Architect's Supplemental Instructions

Architect's ASI No: 046

Project:
Webster University
Interdisciplinary Science
Building

Discipline Code: 03 Electrical

LEVEL 01 AREA A FLOOR
PLAN - LIGHTING

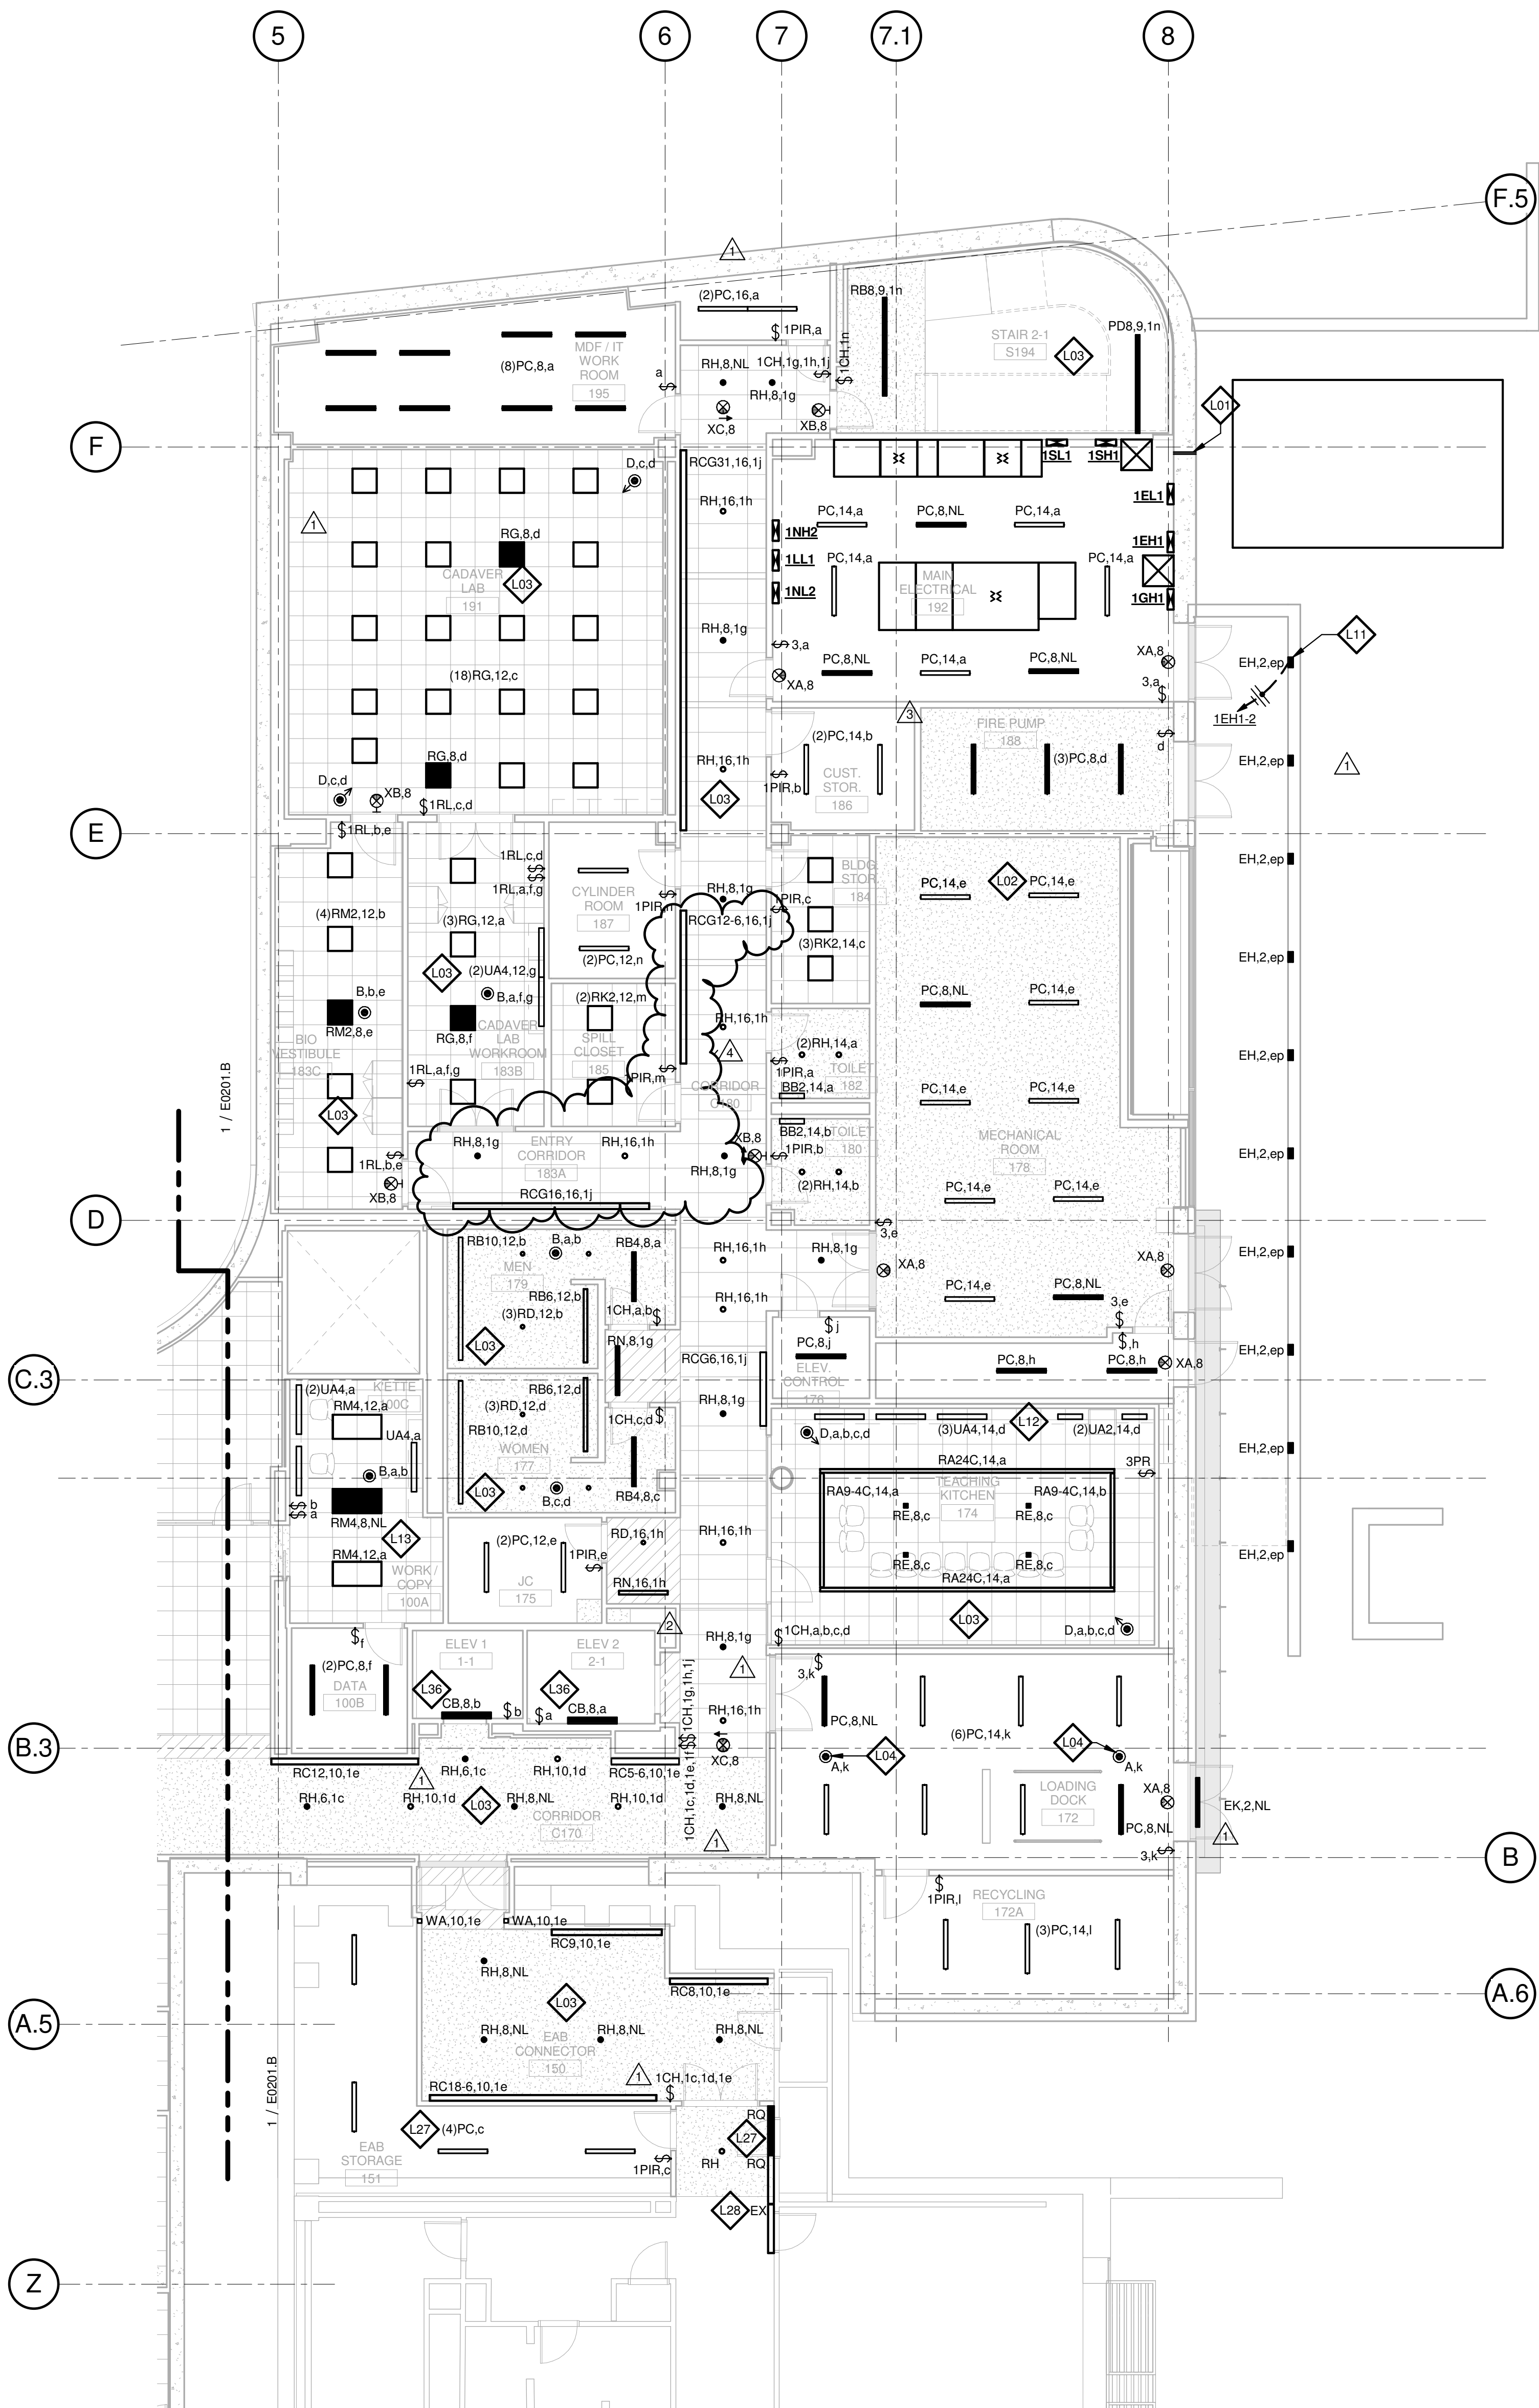
- In Entry Corridor 183A, reconfigure Type RCG18-8 to become a 16' long Type RCG16 fixture.
- In Entry Corridor 183A, shift three Type RH downlights north by 2'.
- In Corridor C18, reconfigure Type RCG10 to become a 12'-6" long Type RCG12-6 fixture.

**LEVEL 02 AREA A FLOOR
PLAN - LIGHTING**

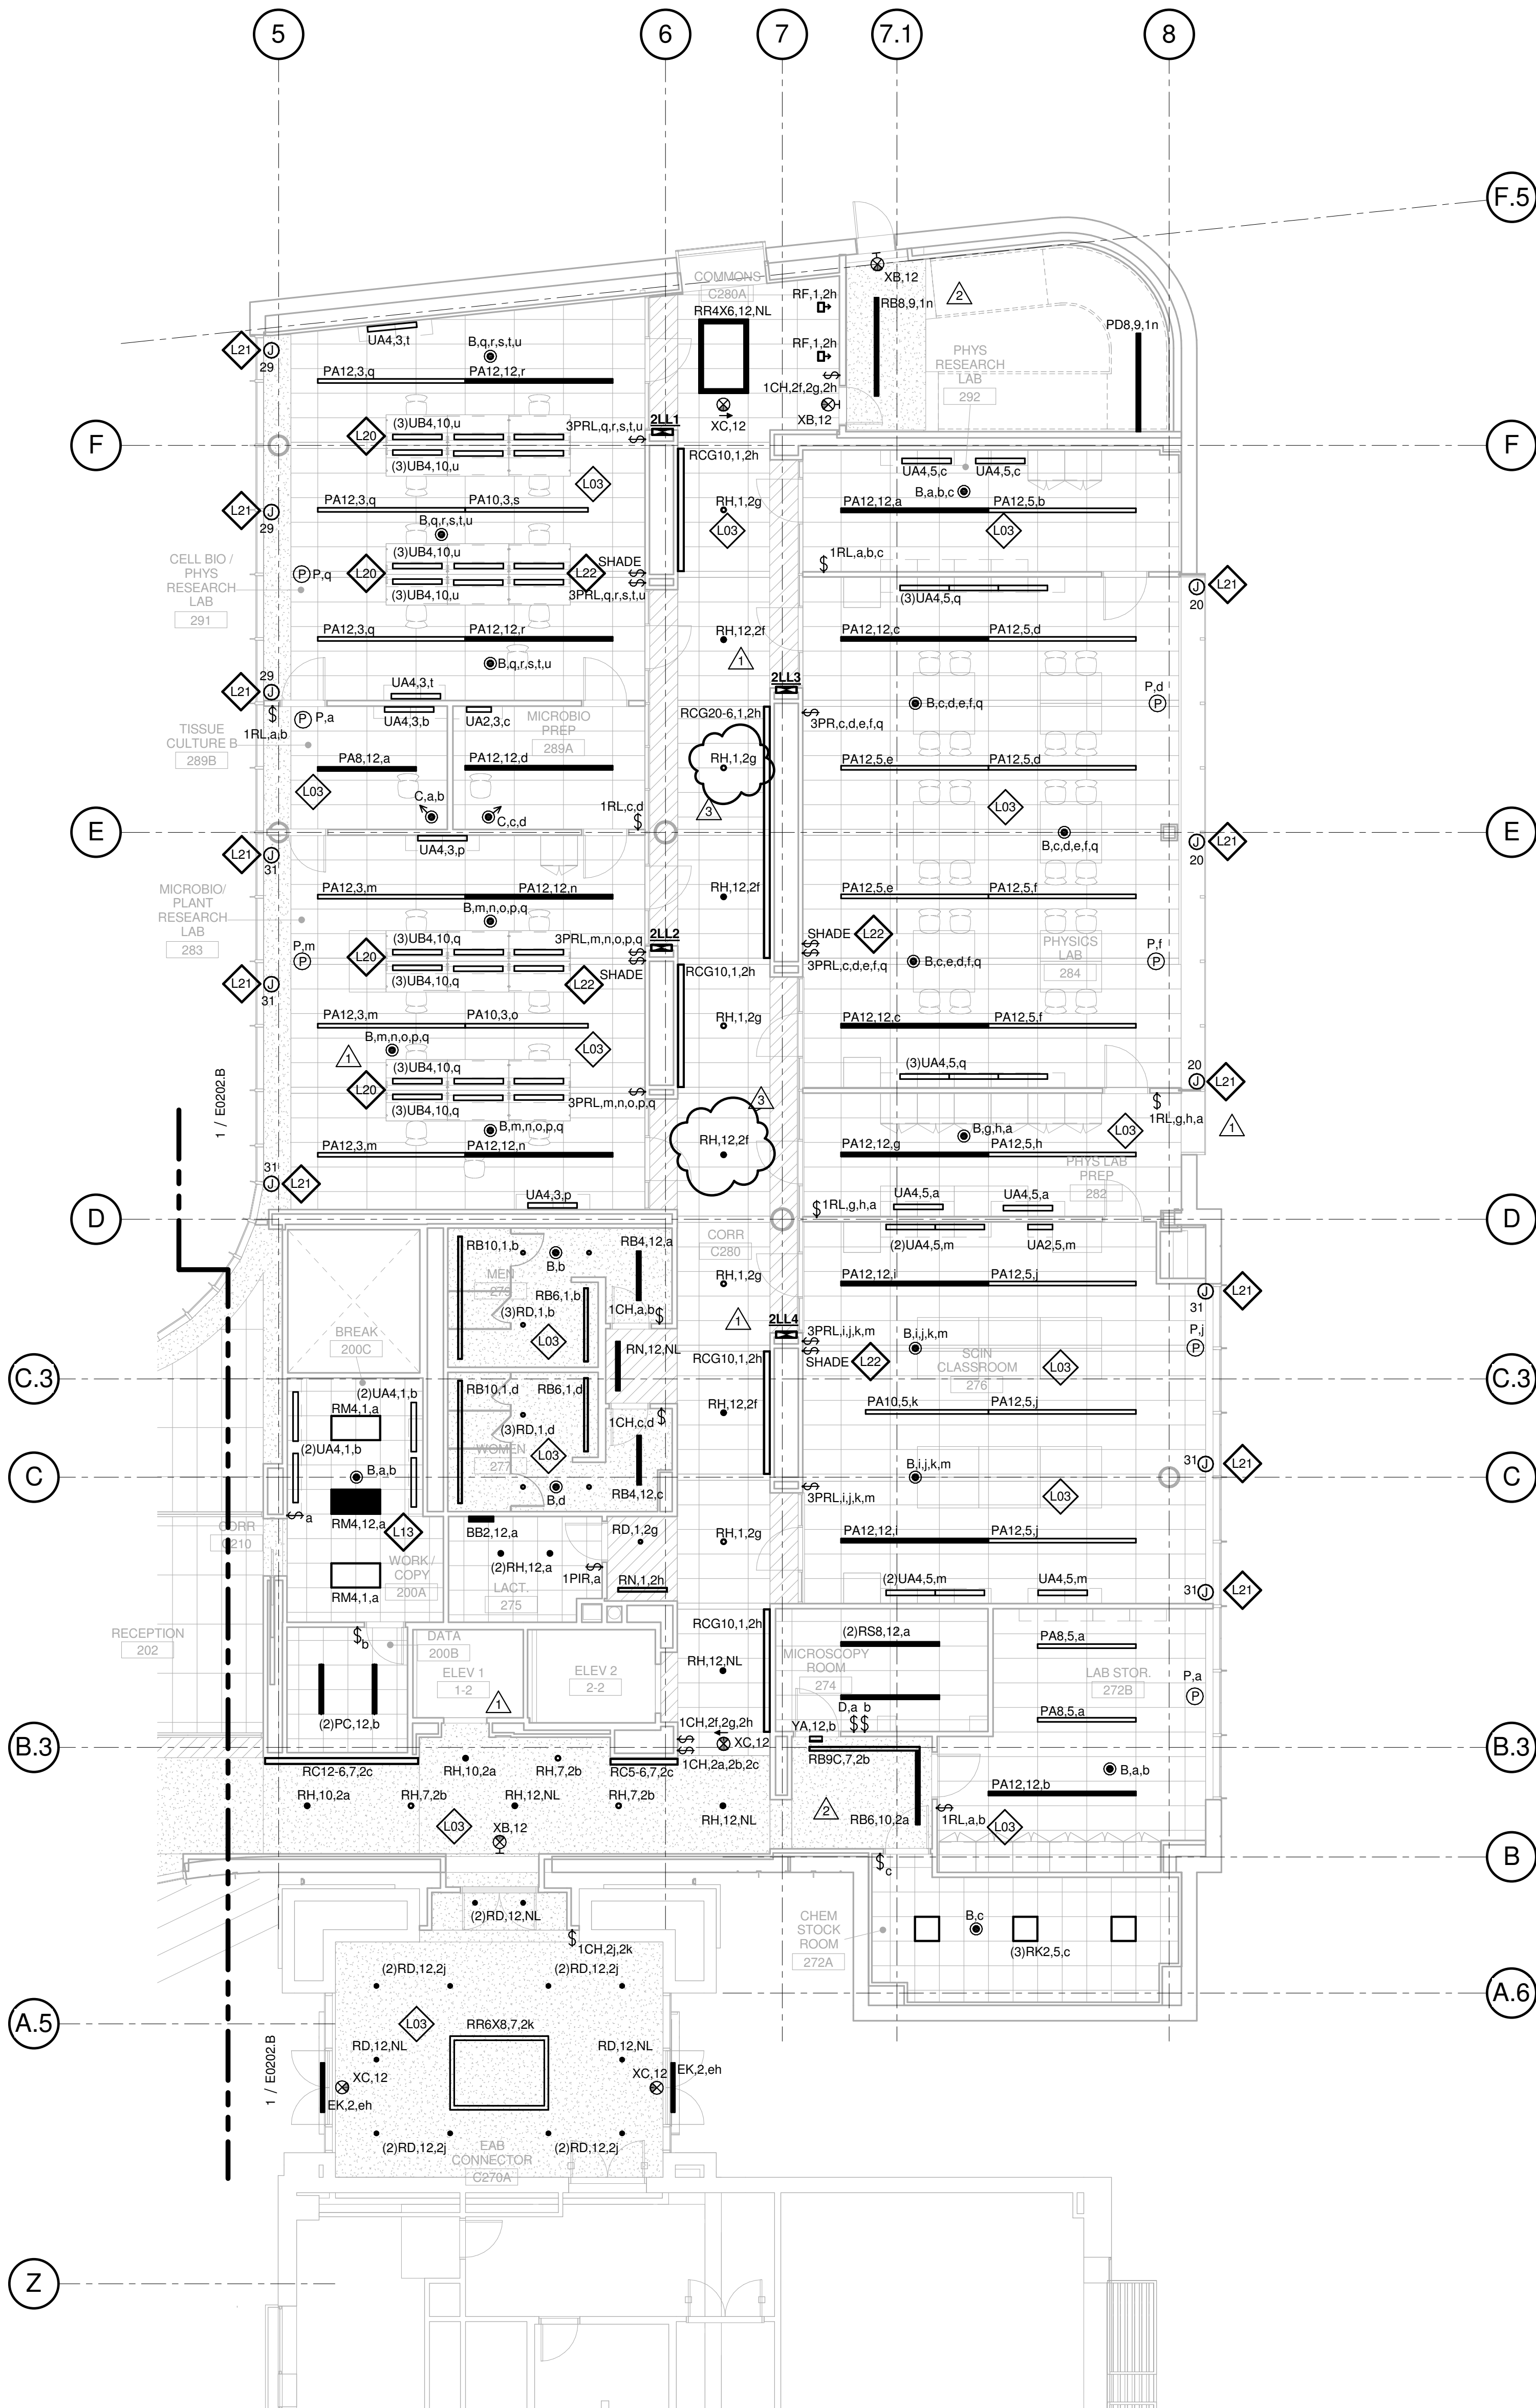
- In Corridor C280, shift two Type RH downlights 2' and center within their bay.

LEVEL 04 AREA A FLOOR PLAN - LIGHTING

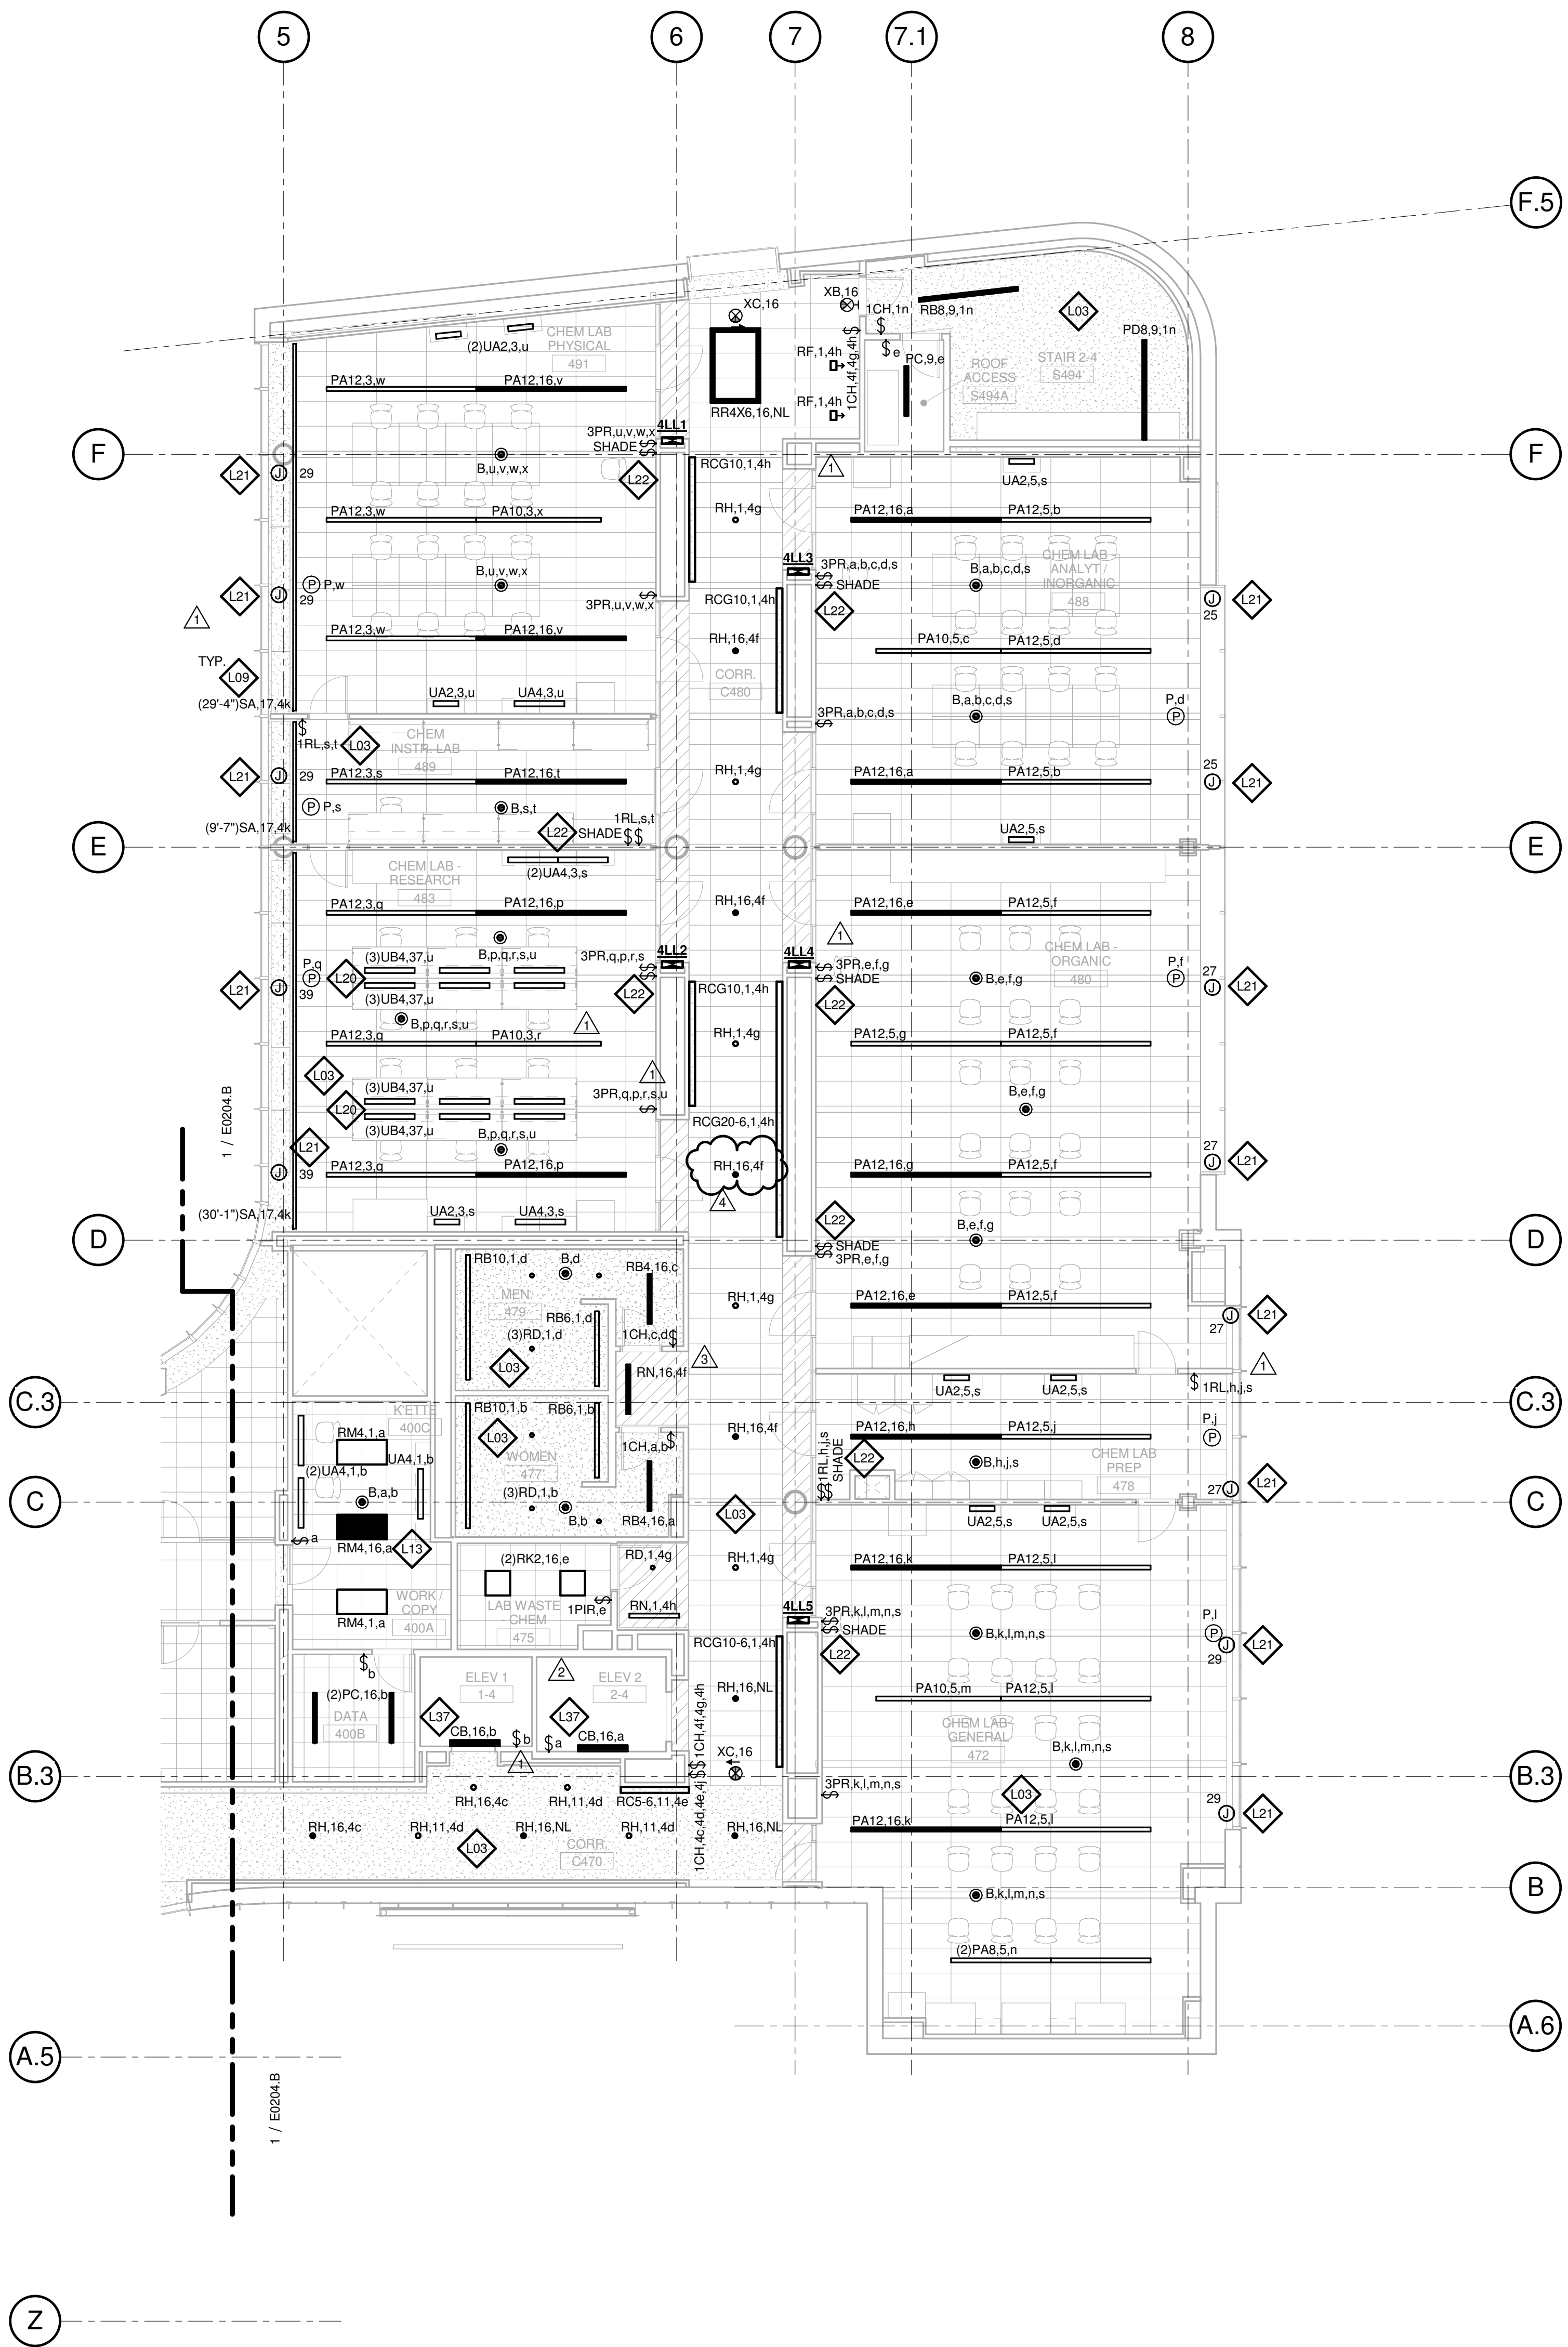
- In Corridor C480, shift one Type RH downlight 2' and center within its bay.
